REPORT NUMBER SRD-79-76  
DATE April, 1976

CRITIQUE OF THE GENERAL ELECTRIC SAFETY-RELIEF

VALVE DISCHARGE ANALYTICAL MODELS

**IDAHO NATIONAL ENGINEERING LABORATORY**

Figure 1. Pressure Field Due to Sink and Source

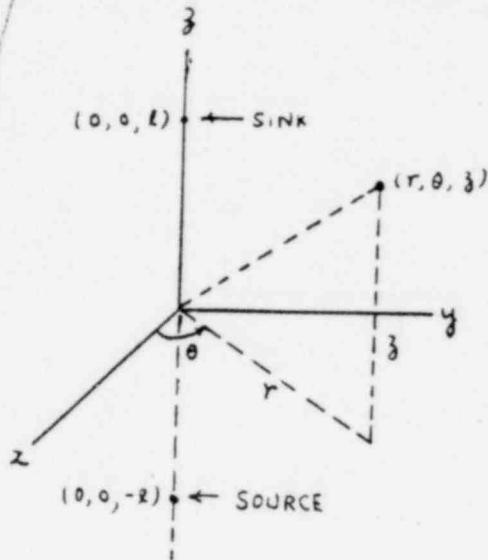
To satisfy the free surface boundary condition, on page 21 of NEDE-20942-P, it is stated that "...it suffices to balance each bubble (real and imaginary) by a "sink" which is the mirror image of that bubble but its pressure field has the opposite sign". Based on Equation (3-6), it is seen that, unlike the velocity field, a new physically acceptable pressure field is not generated by simply changing the sign of a known physically acceptable pressure field (which, by definition, is a pressure field compatible with basic equations of motion). Thus it seems that the previously quoted statement needs some further explanation. A sink, strictly speaking, should be defined as the mirror image of the source but its corresponding velocity field has the opposite sign. A sink can be used to satisfy the free surface boundary condition approximately (a free surface boundary condition is well approximated if the gradient of pressure along any direction in the free surface is much smaller than that along the direction normal to the free surface) if the following condition is satisfied, i.e.,

for any point on the free surface. (It is noted that the true meaning of Equation (3-11) is explained in Figure 1). Equation (3-11), apparently, can be satisfied if the distance between source and sink is large enough.

If this condition is satisfied, then the second term in the right hand side of Equation (3-6) can be dropped. Thus we conclude that the approximate pressure field of a sink is the negative of that of a corresponding source.
